Access Compliance Report Public Rights-of-Way (Curb Ramps)

Main Street: GILLY_FLOWER_ST		Cross Street: STRAWFLOWER_ST		Location:	NE
ADA ID: RPAT211102134856	Ramp Type: Type 4 - Parallel	Initial Pass/Fail: Fail	Overall Compliance: No	Severity Score:	16

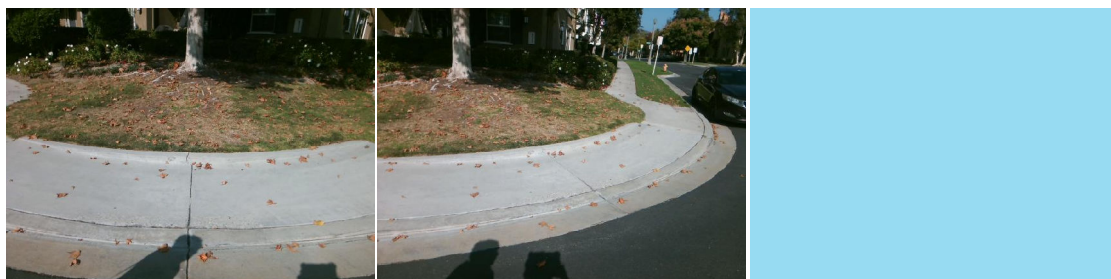
Compliance	Description	Data	Compliance	Description	Data
N/A	Ramp Length LT (in)	110	N/A	Ramp Length RT (in)	100
Yes	Ramp Width LT (in)	53	Yes	Ramp Width RT (in)	53
Yes	Ramp Run Slope LT (%)	1.5	No	Ramp Run Slope RT (%)	9.1
No	Ramp Cross Slope LT (%)	4.5	No	Ramp Cross Slope RT (%)	2.6
N/A	Landing Present	N/A	N/A	DWS Provided	N/A
N/A	Landing Length (in)	N/A	N/A	DWS Contrast	N/A
N/A	Landing Width (in)	N/A	N/A	DWS Length (in)	N/A
N/A	Landing Run Slope (%)	N/A	N/A	DWS Full Width	N/A
N/A	Landing Cross Slope (%)	N/A		DWS Offset Type	N/A
N/A	Landing Movement Obstructed?	N/A	N/A	DWS Offset Left (in)	N/A
	Landing Movement Type	N/A	N/A	DWS Offset Right (in)	N/A
N/A	Landing Shared	N/A			
N/A	Clear Space	Yes			
N/A	Clear Space To Crosswalk (in)	N/A			
N/A	Marked Crosswalk 1	No	N/A	Marked Crosswalk 2	No
	Crossing 1 Direction	SW		Crossing 2 Direction	SE
	Marked Crosswalk 1 Width (in)	N/A		Marked Crosswalk 2 Width (in)	N/A

N/A	Ramp Inside Crosswalk 1	N/A	N/A	Ramp Inside Crosswalk 2	N/A
	Crossing 1 Slope (%)	1.6		Crossing 2 Slope (%)	2.8
	Crossing 1 Cross Slope (%)	3.6		Crossing 2 Cross Slope (%)	0.4
N/A	Gutter Ponding	N/A	N/A	Curb Slope	9.8
Yes	Gutter Lip Height (in)	0		Road Run Slope (%)	2
N/A	Gutter Run Slope (%)	N/A		Road Cross Slope (%)	3.5
N/A	Gutter Cross Slope (%)	N/A	No	Perpendicular Joint Present	No
Yes	Overall Surface Condition	Acceptable			
	Cross Gutter Present?	No		Spandrel Present?	No
	Replace Cross Gutter?	N/A		Replace Spandrel?	N/A

Remove & Replace Curb Ramp With Two New Directional Ramps or Equivalent.
